ADDENDUM No. 1

DATE: November 22, 2024

PROJECT: Village of Algonquin
Braewood Pump Station Rehabilitation

TAI PROJECT NUMBER: ALG-037

Braewood Pump Station Rehabilitation
Site Demolition Plan
 Algonquin, Kane County, Illinois

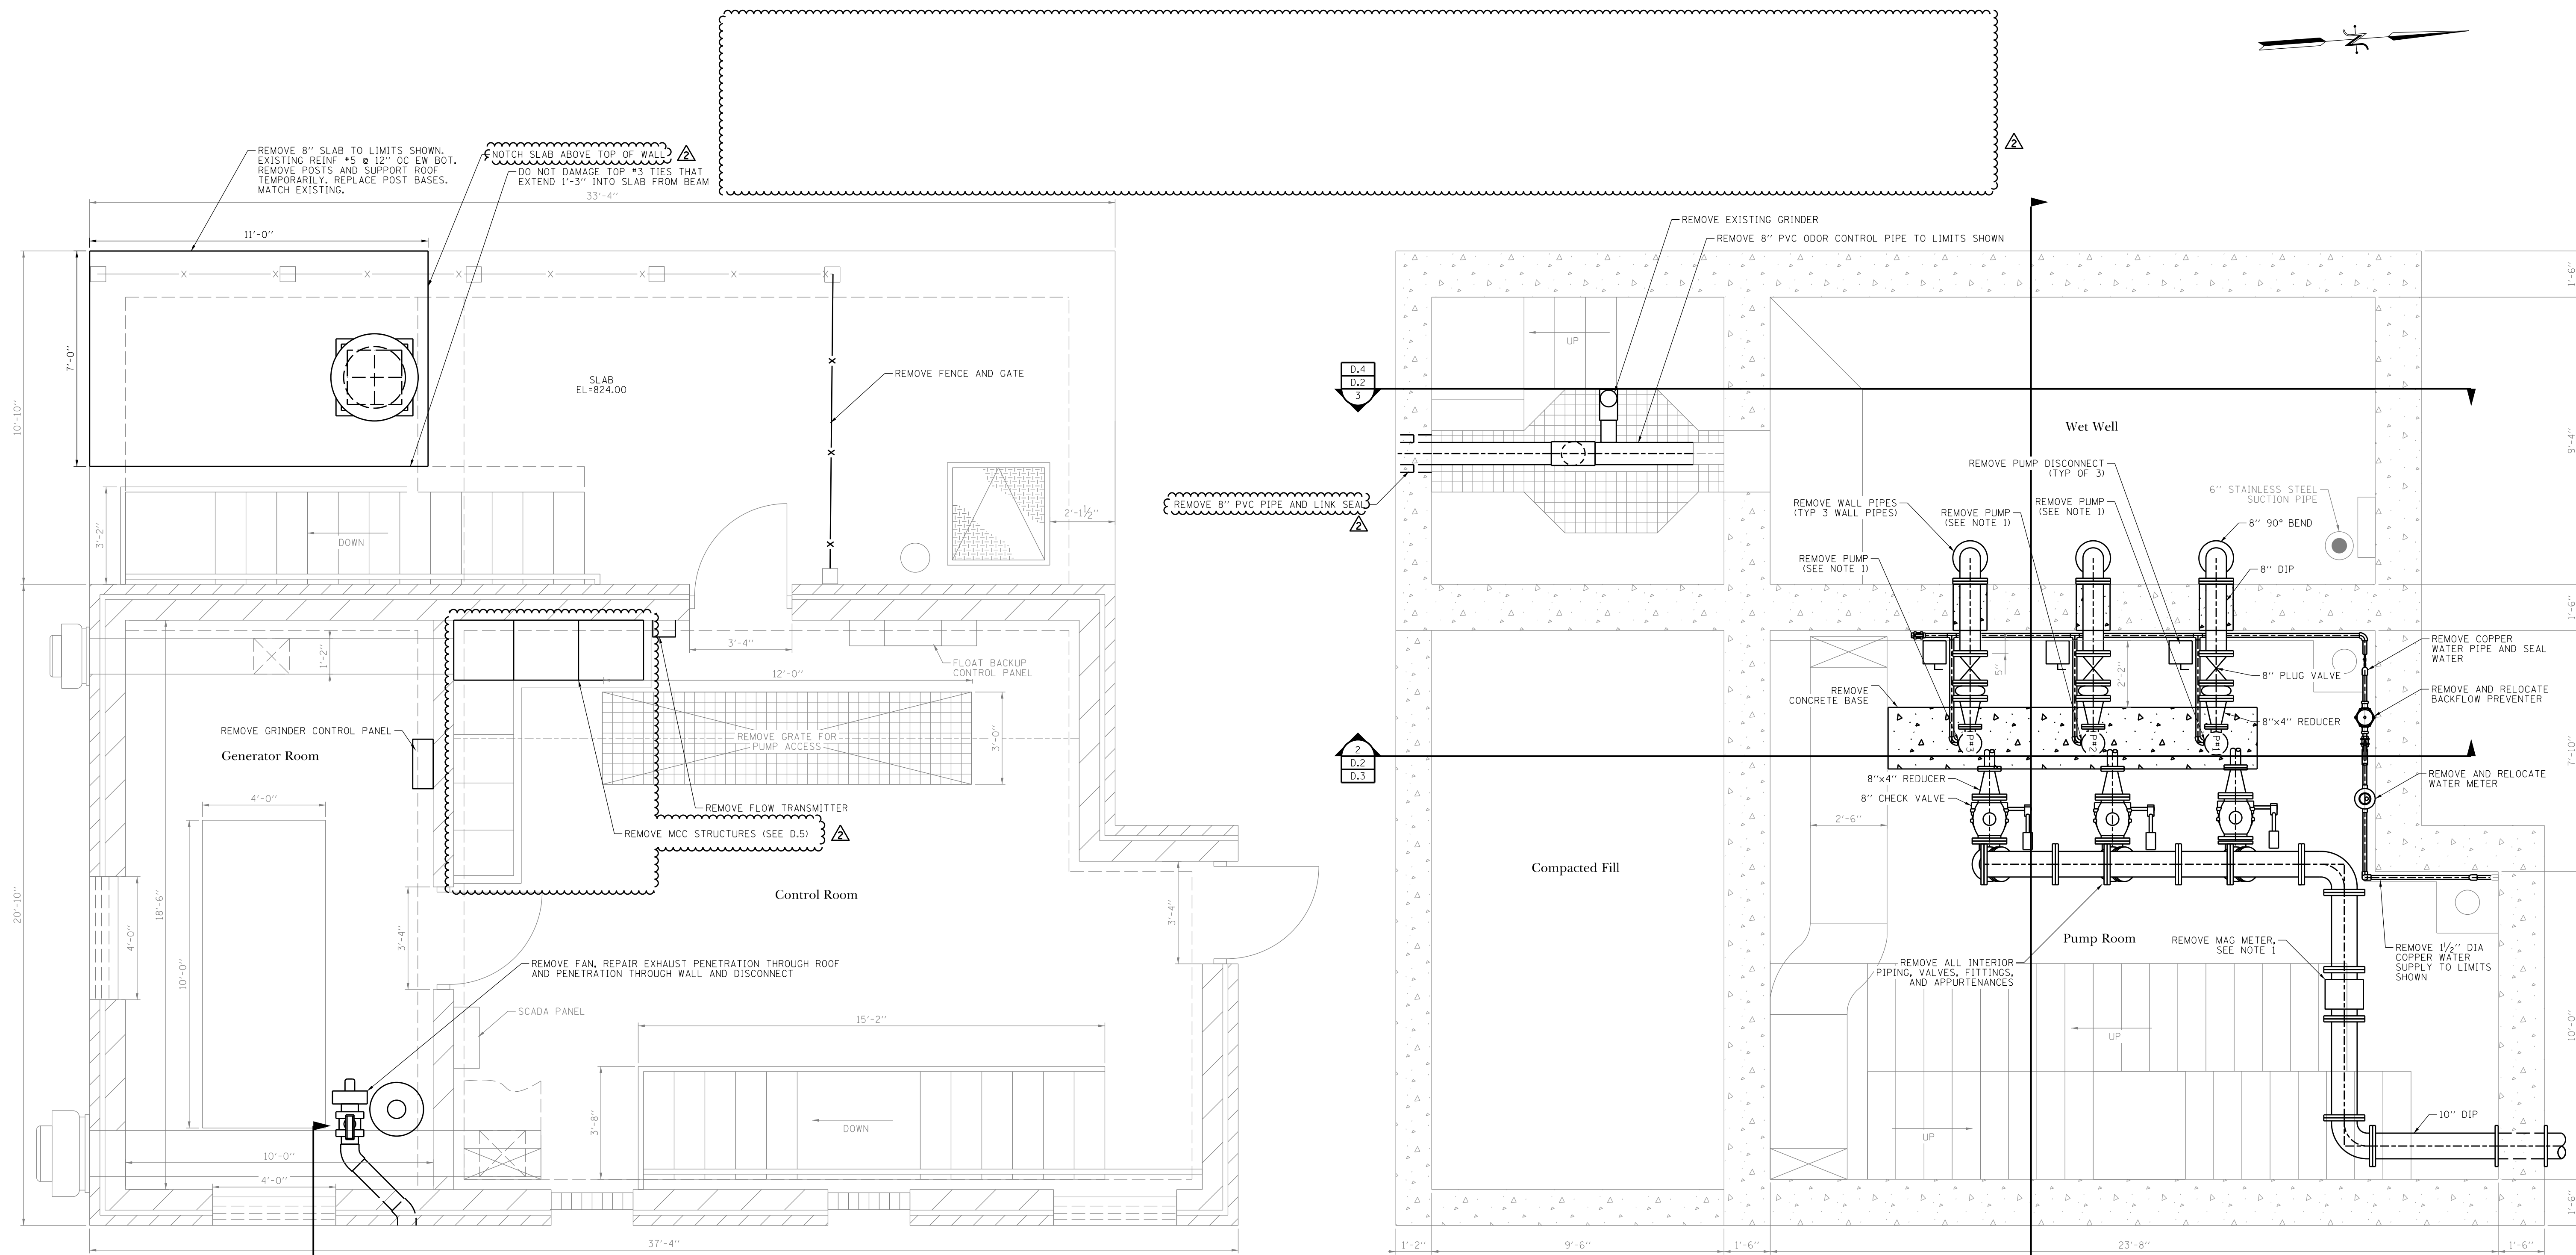
1. Sheet D.1 – Site Demolition Plan

- A. Additional fence removal and reinstallation added.
- B. Existing site piping revised and pavement removal and curb and gutter removal/replacement limits expanded.
- C. Existing grounding wire shown around existing building.
- D. Existing odor control piping shown and removal limits expanded.

Upper Level Pump Station Demolition Plan
SCALE: 3/8" = 1'-0"

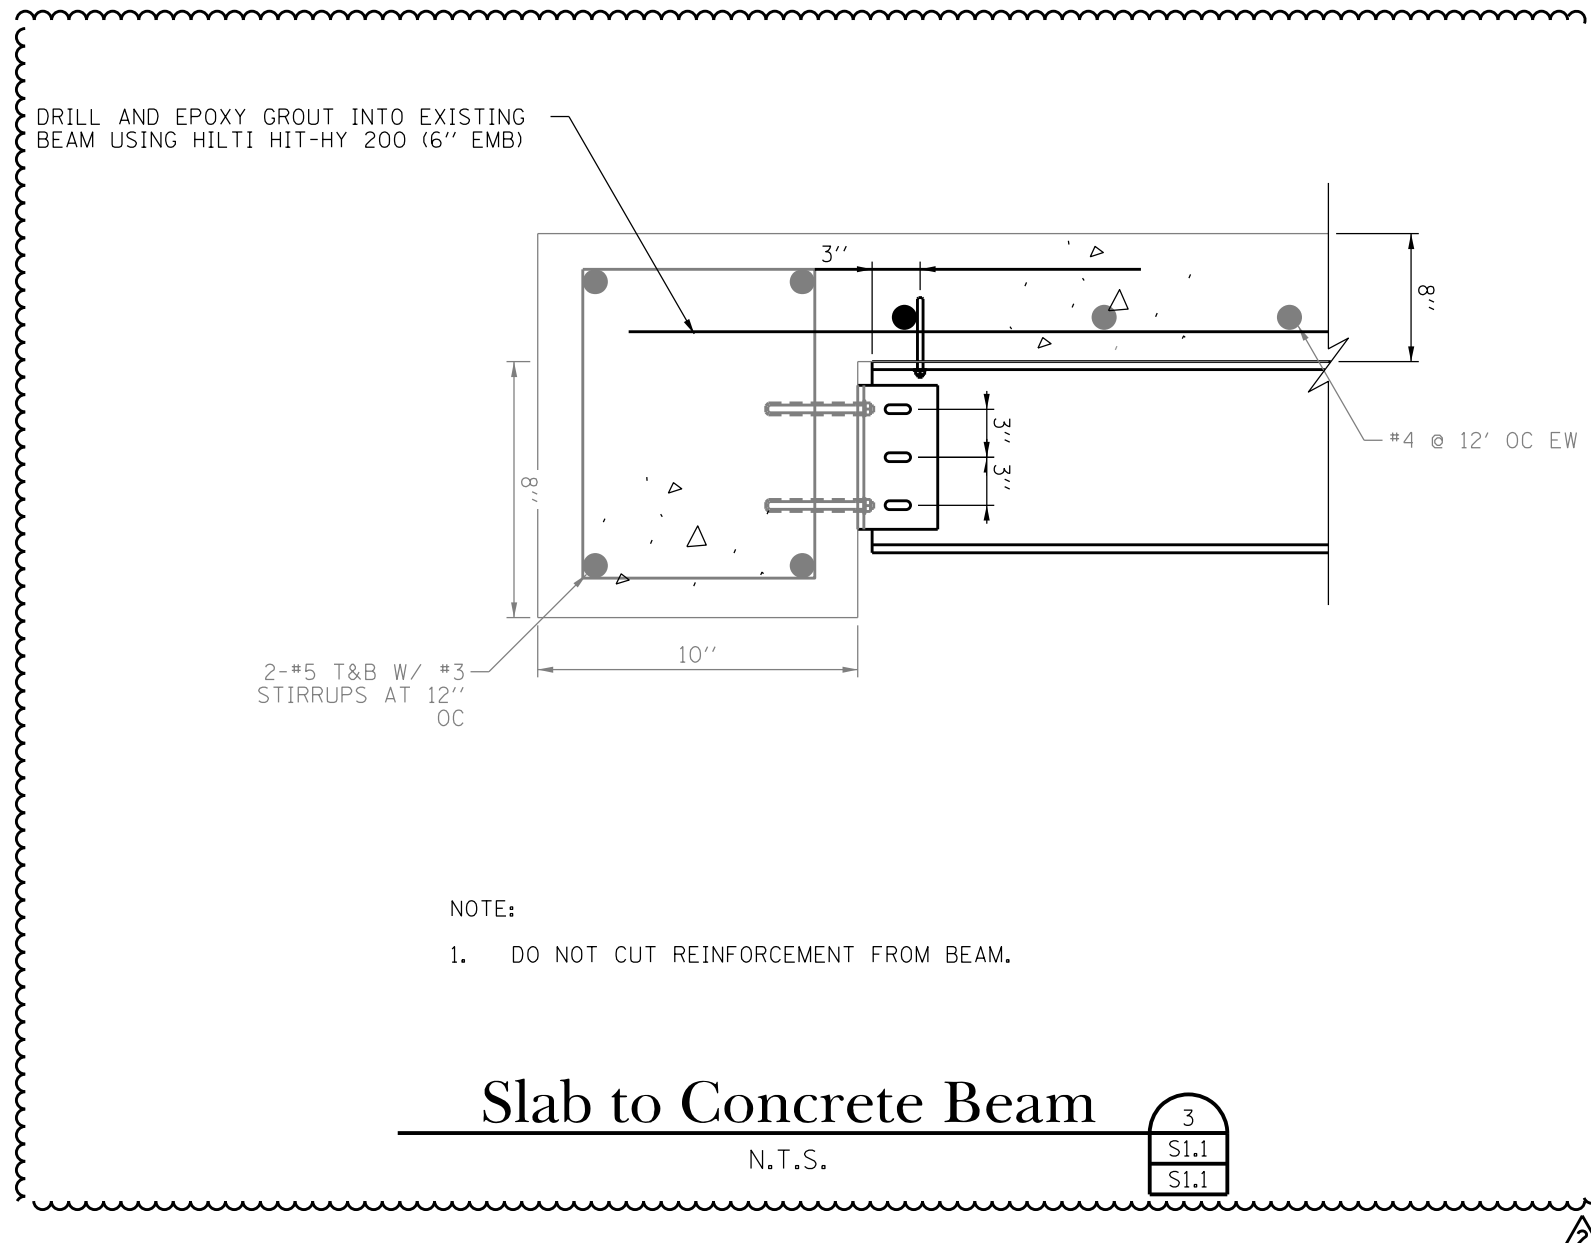
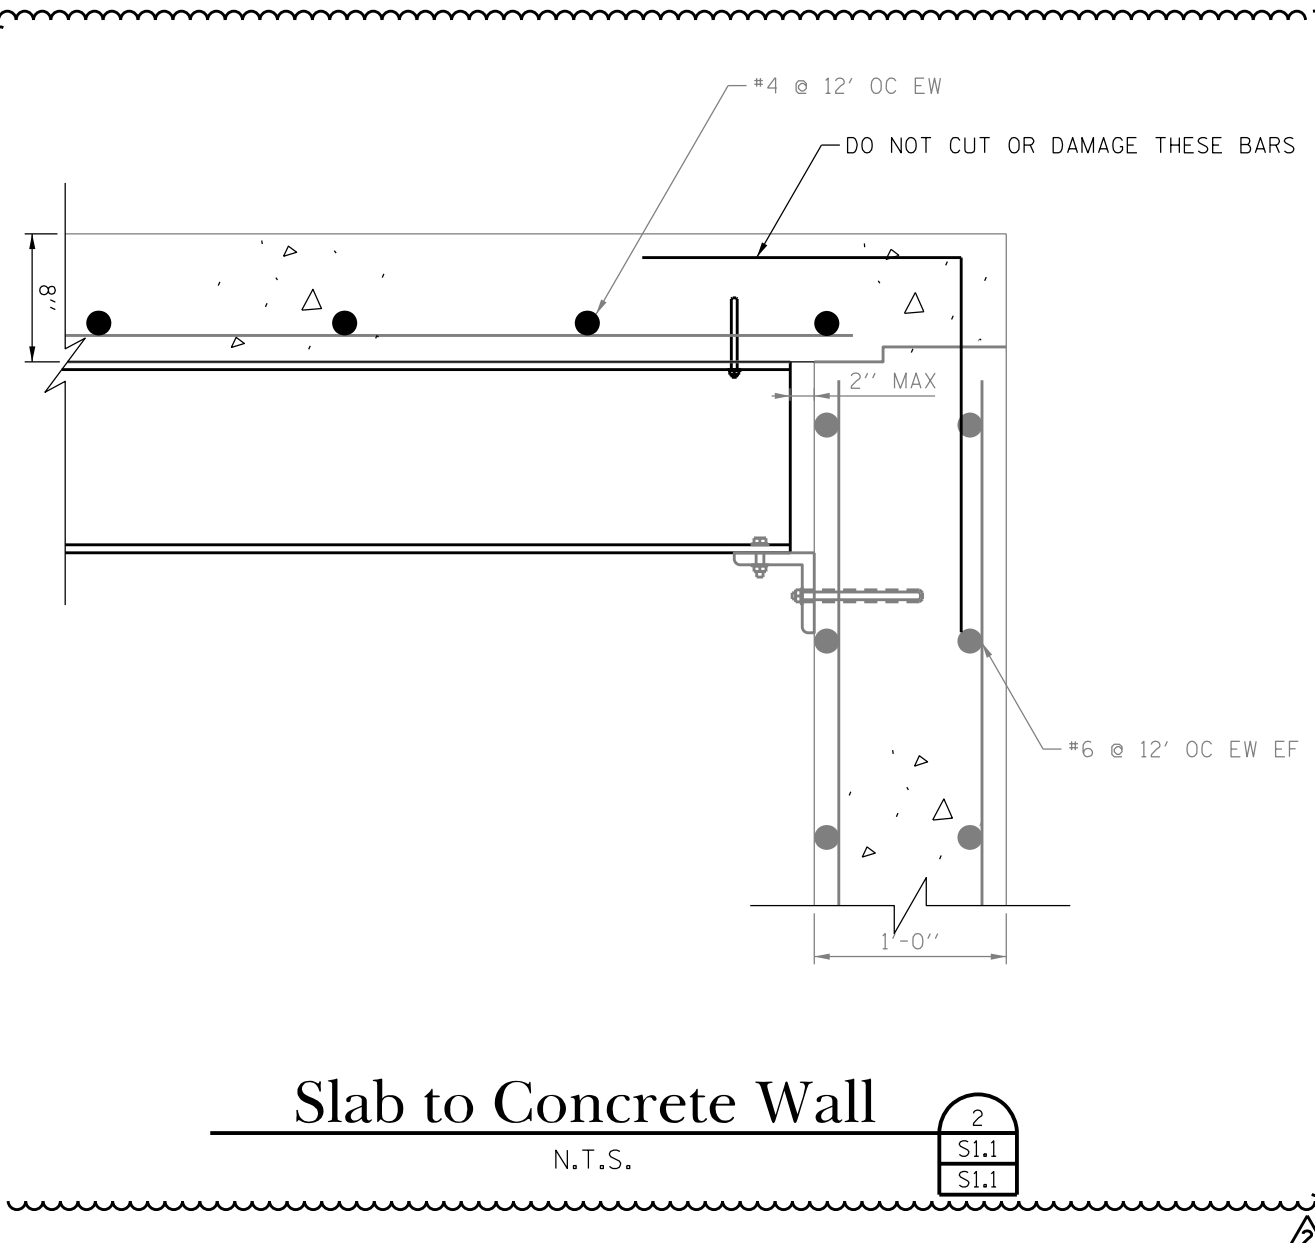
2. Sheet D.2 – Upper and Lower Demolition Plan

- A. Slab details replaced.
- B. Existing odor control piping removal limits expanded.
- C. Existing concrete pad added beneath existing MCC.
- D. Key Note #2 added.

Demolition Section 3
D.2
D.4
SCALE: 1/2" = 1'-0"

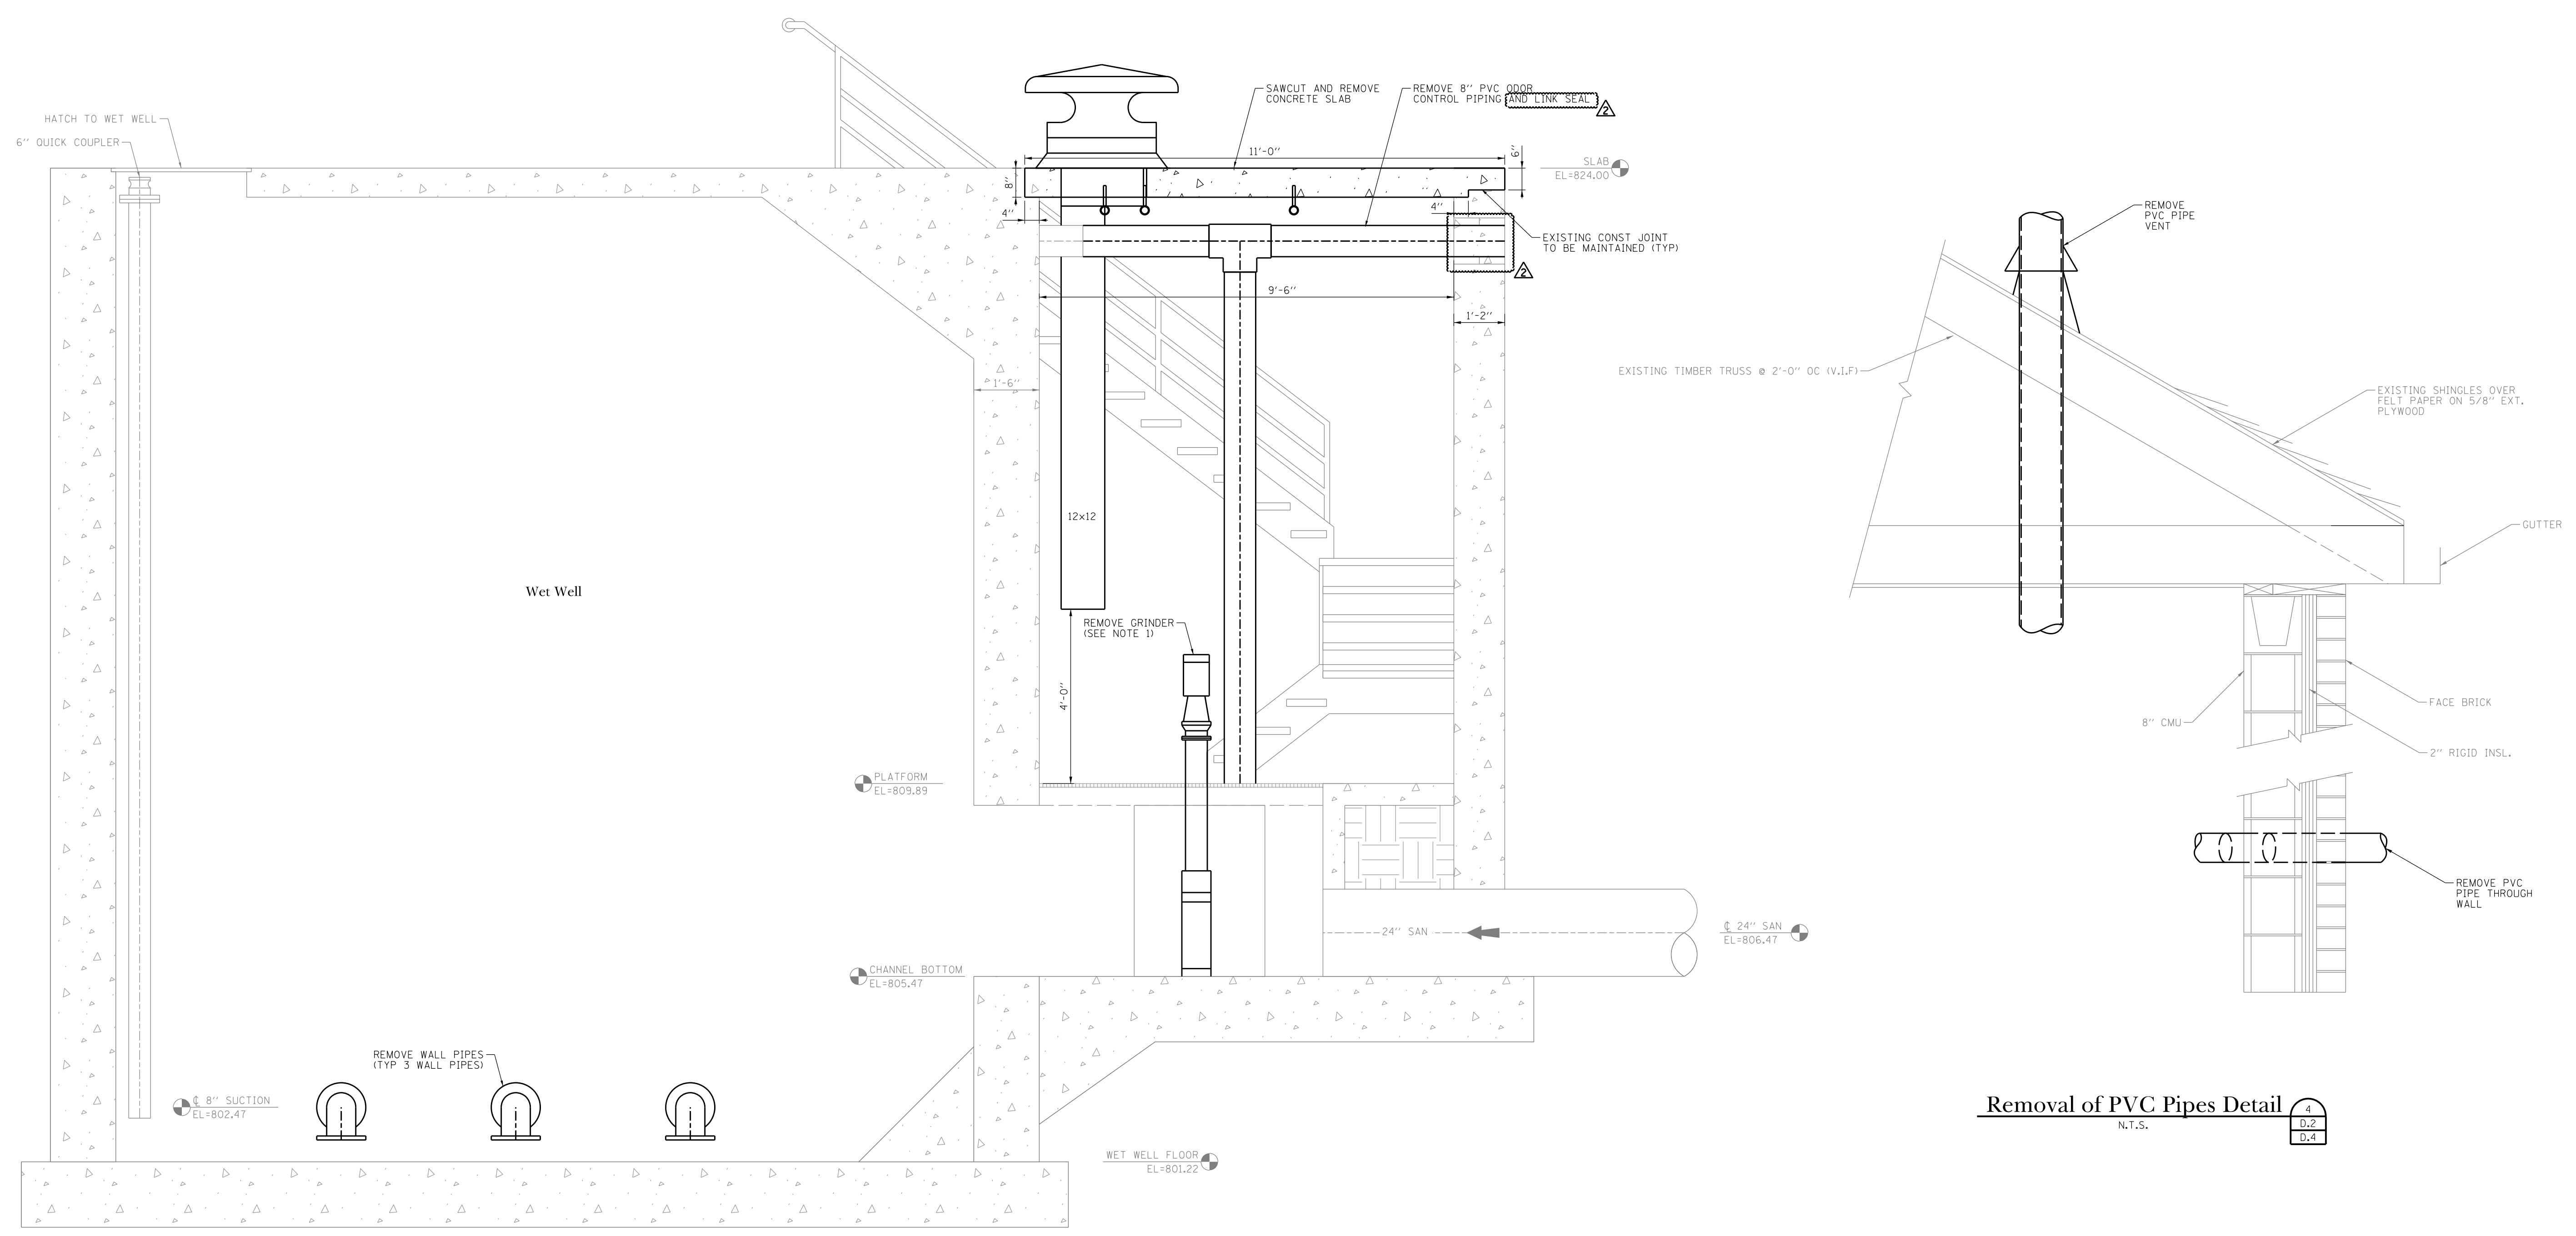
3. Sheet D.4 –Demolition Section

- A. Existing odor control piping removal limits expanded.
